ADDITIONAL INFORMATION
AND
STATUS OF VARIOUS NUREG-0737 ITEMS

COMMONWEALTH EDISON COMPANY

Dresden Station Units 2 and 3
Quad Cities Station Units 1 and 2
Zion Station Units 1 and 2

RESPONSES TO NRC REQUEST FOR ADDITIONAL INFORMATION
ON THE WESTINGHOUSE R.V.L.I.S.
SUMMARY REPORT
(7300)(ZION)

Figure 1

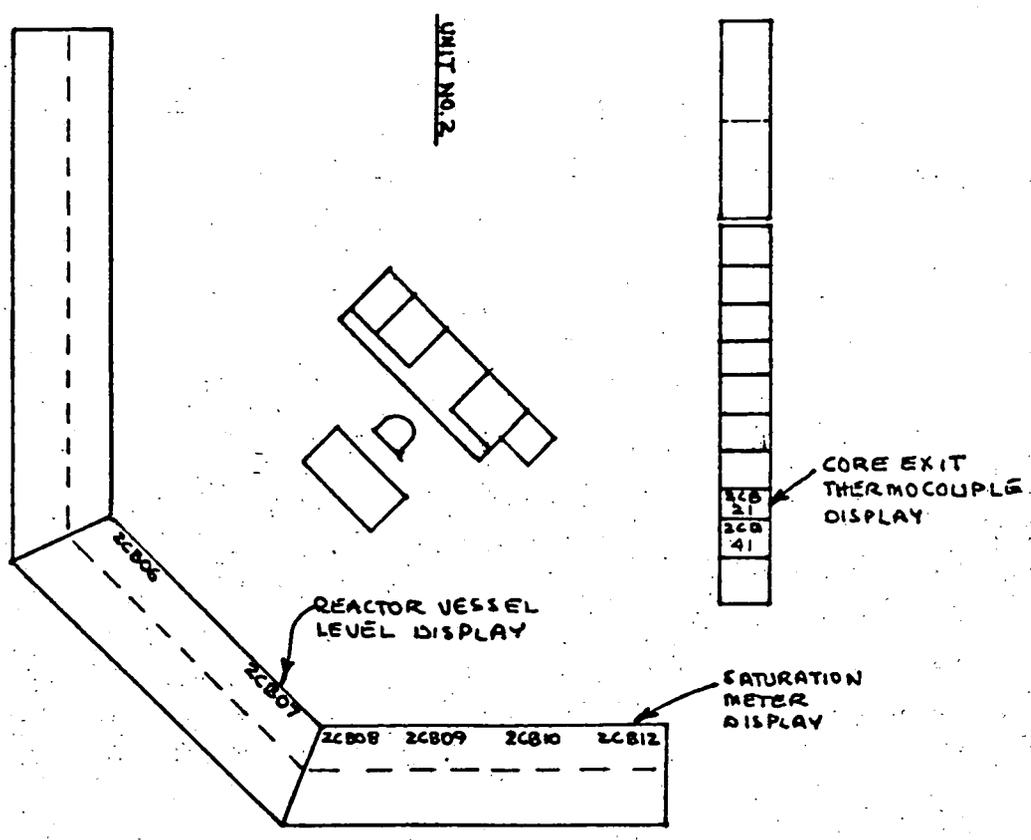
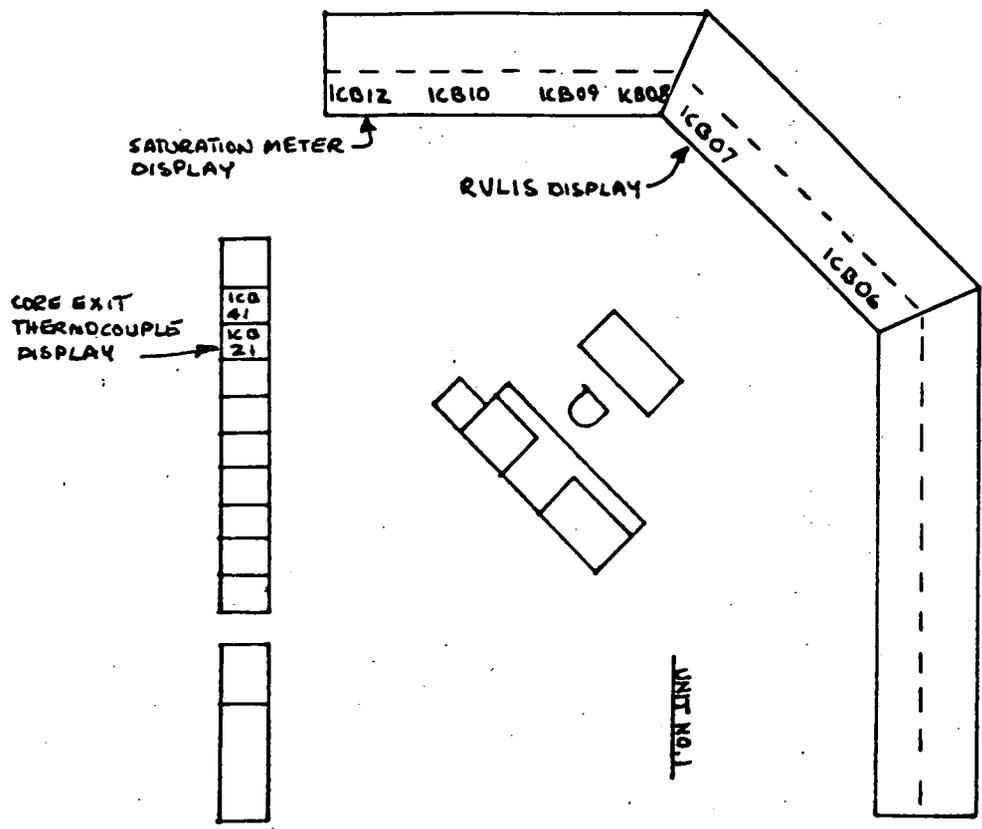
Describe the location of the level system displays in the control room with respect to other plant instrument displays related to ICC monitoring, in particular, the saturation meter display and the core exit thermocouple display.

See Figure 1

NON-UHI CORE EXIT T/C DIAGRAM

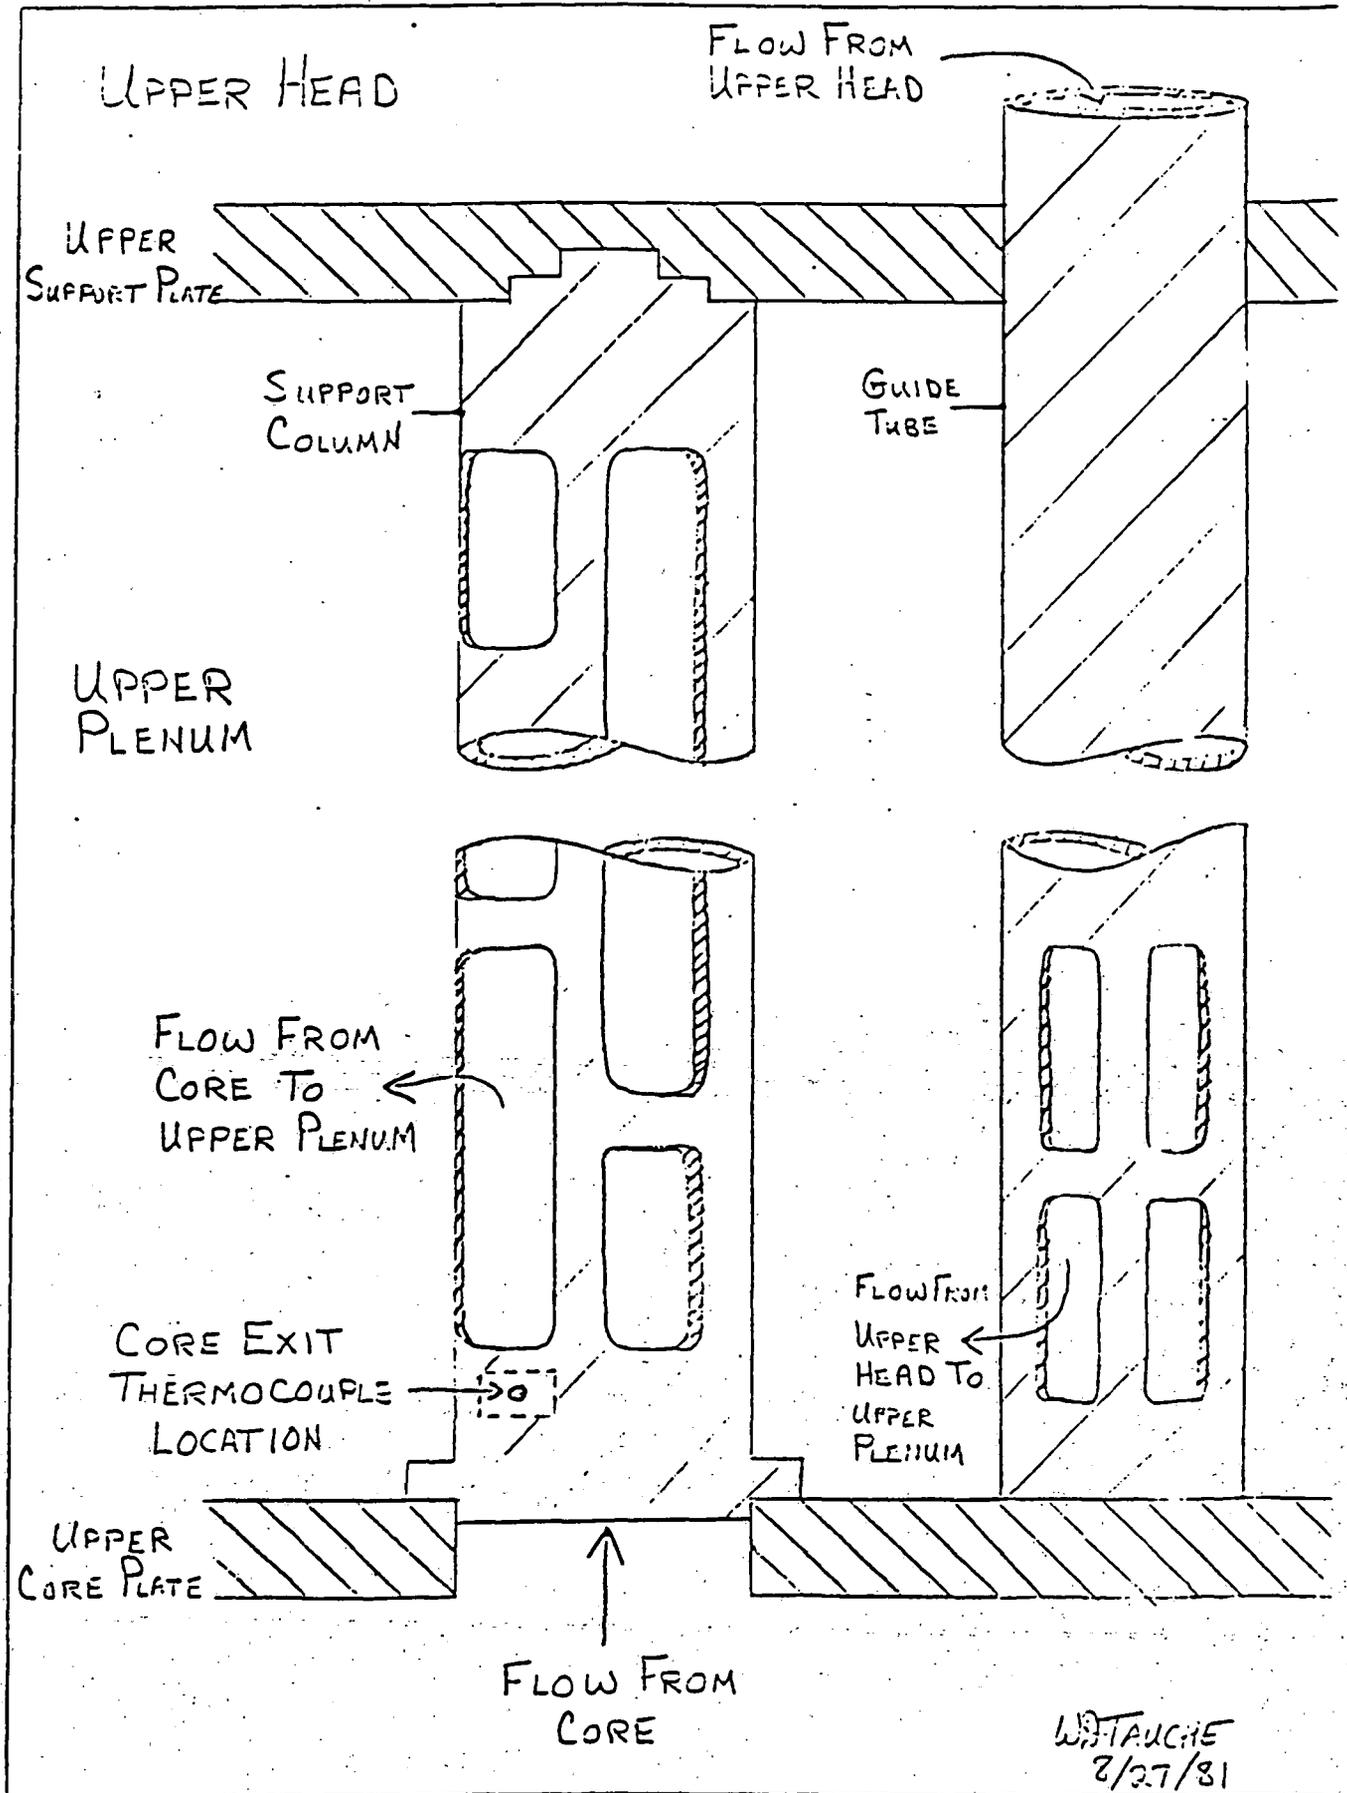
In some tests at Semi-scale, voiding was observed in the core while the upper head was still filled with water. Discuss the possibility of cooling the core-exit thermocouples by water draining down out of the upper head during or after core voiding with a solid upper head.

19. One of the indicators of an approach to an Inadequate Core Cooling (ICC) situation is the response of the core exit thermocouples (T/Cs) to the presence of super-heated steam. The core exit thermocouples will not provide an indication of the amount of core voiding. Response of the core exit T/Cs provides a direct indication of the existence of ICC, the effectiveness of ICC recovery actions, and restoration of adequate core cooling. The core is adequately cooled whenever the vessel mixture level is above the top of the core and the core may have a significant void fraction and still be adequately cooled.

Realistically, an indication of an ICC condition would not occur until the primary coolant system has drained sufficiently for the reactor vessel mixture level to fall below the top of the core. Westinghouse has performed analyses which indicate that the upper head will drain below the top of the guide tubes before ICC conditions exist. The guide tubes are the only flow path from the upper head to the upper plenum. In WCAP-9754, "Inadequate Core Cooling Studies of Scenarios With Feedwater Available, Using the NOTRUMP Computer Code", it was found that inadequate core cooling situations would not result for LOCAs of an equivalent size or equal to approximately 6 inches or less without two or more failures in the ECCS. In both specific scenarios examined in WCAP-9759, a 1-inch and 4-inch small LOCA, the upper head and upper plenum had completely drained before the onset of an ICC condition.

In the Zion plant, the core exit T/Cs protrude slightly from the bottom of the support columns (see attached Figure). In this location, they measure the temperature of the fluid leaving the core region through the flow passages in the upper core plate. Flow from the upper head must enter the upper plenum via the guide tube before being able to enter the upper core plate flow passages. In addition, the LOCA blowdown depressurization behavior must be such that there is a flow reversal for the core exit T/Cs to detect the upper head fluid temperature. The upper head fluid is expected to mix with the upper plenum fluid as it drains from the upper head.

The potential for core exit T/C cooling from colder upper head fluid, while the core has an appreciable void fraction is not viewed as a potential problem for the detection of an inadequate core cooling situation. Although some Semi-scale tests indicated core voiding while the upper head was liquid solid that does not imply that the core exit T/Cs would give an ambiguous indication of ICC calculations for a Westinghouse PWR and consideration of the core exit T/C design would not result in ambiguous ICC indications.
